Exhibit DVP-003

In the Matter of)	
)	
Dominion Virginia Power)	Docket No. 52-017-COL
)	
North Anna Power Station, Unit 3)

**DOMINION VIRGINIA POWER'S
RESPONSES TO PRE-HEARING QUESTIONS**

Figure Q1-1 – Typical Subsurface Profile across Unit 3 Power Block Area
(FSER Figure 2.5.4-1 Modified to Remove Vertical Exaggeration)

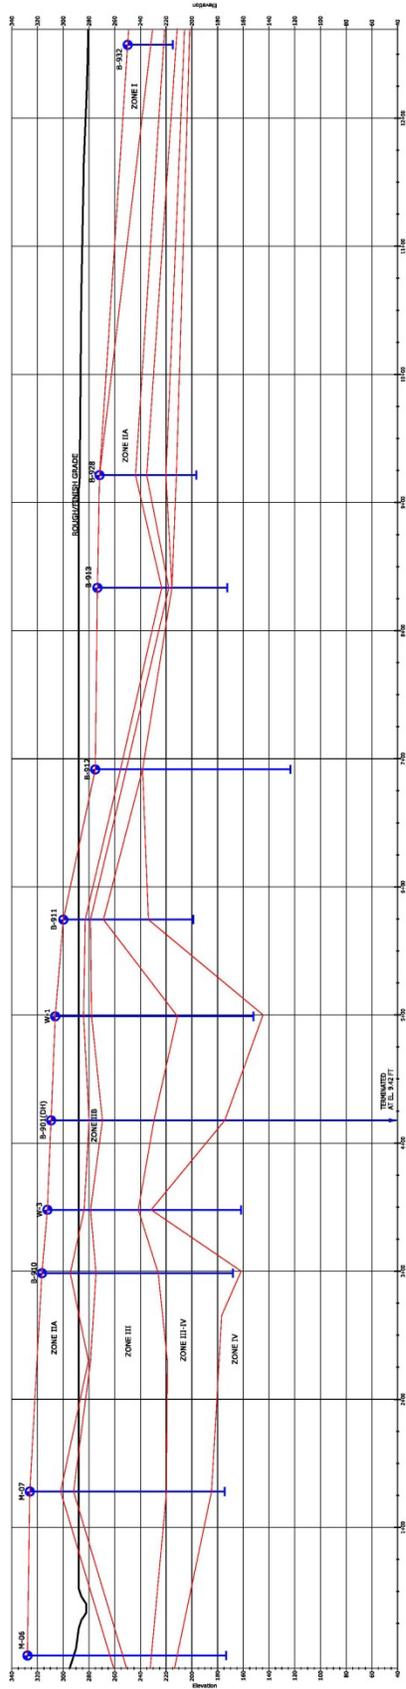
Question 1: In Request for Additional Information 5693, 2.5.2-3a, dated May 5, 2011 (ML11125A124), the Staff asked the Applicant to justify the one-dimensional (1D) site response analysis using only vertically propagating shear waves, given the complex topography of the subsurface layers. On August 25, 2011 (ML11241A058), the Applicant responded that the soil and rocks at the site are all derived from the same parent rock. The Applicant attributed the subsurface variability to the localized effects of weathering on minerals comprising the parent rock rather than to deposition of soil as distinct layers. For lateral variability, the Applicant states that the boundaries between rock types are gradational and so do not represent lateral impedance boundaries that may result in refraction, reflection, or trapping of the shear waves traveling in horizontal directions. Therefore, the site can be characterized as undulating, but not *dipping*, thus justifying the 1D analysis. The Applicant uses the same weathering process to explain the existence of vertical variation, but with distinct boundary impedances at different depths as shown in Final Safety Evaluation Report (FSER) Figure 2.5.2-5. Please discuss why the same weathering mechanism generates sharp boundaries vertically, but not laterally.

The end product of rock weathering depends on the composition of the rock and the weathering processes. The various stages of the weathering in place of the North Anna bedrock can be seen in Figure Q1-1 (FSER Figure 2.5.4-1 modified to remove the vertical scale exaggeration). The sound bedrock (Zone IV) degrades to slightly-to-moderately weathered rock (Zone III-IV), then weathered rock (Zone III), then saprolite (Zones IIA and IIB) which is mainly granular soil that still exhibits the structure of the bedrock, and finally clay soil (Zone I) which contains no relict bedrock structure and is now mostly absent from the site. Because of the vertical progression of the weathering process, these zones are nominally horizontal. Some random lateral variation (as seen in Figure Q1-1) occurs because the weathering processes are not always uniform, and the rock is not entirely homogeneous. It should be noted that the zone separations depicted on the figure are made by joining the zone boundaries in the borings by straight lines for simplification

– in reality these changes will be a gradual transition (similar to the ground surface) and thus the description of “undulating.”

The question references FSER Figure 2.5.2-5 (shear wave velocity (V_s) profiles for the Reactor Building/Fuel Building (RB/FB) and Control Building (CB) used in site response analysis) as depicting the distinct boundary impedances at different depths. As described above, these are boundaries of variation of impedance in the vertical direction (termed “vertical impedance boundaries” here) defined by the approximately horizontal zone boundaries caused by weathering. Because the weathering impact on the rock is severe, the vertical impedance boundaries are significant, as illustrated in FSER Figure 2.5.2-5. The random and relatively small lateral variations as shown on the figure do not produce equivalent lateral impedance boundaries. The vertical impedance boundaries of the V_s profiles in FSER Figure 2.5.2-5 are somewhat simplified for use as input to the site response analysis. The V_s values are averaged over 10 ft intervals, and thus the sharp impedance boundaries in FSER Figure 2.5.2-5 do not reflect the transitions between zones that inevitably occur in a weathering profile. These slight approximations are accounted for in the randomization of the V_s profile as part of the response analysis. Similarly, local variations in the V_s profile due to variations in the weathering patterns are taken into account in the randomization process.

The question notes the reference to the site being characterized as undulating rather than dipping to justify the 1D analysis. In a dipping rock site, layers that are present on one end of the site may be absent on the other end, and vice versa. If these layers have distinctly different dynamic properties (V_s , damping, etc.), then the site response can be quite different at either end of the site – and additional analytical efforts would be needed to reconcile this situation. As described above, this is not the case with the undulations at the North Anna site.
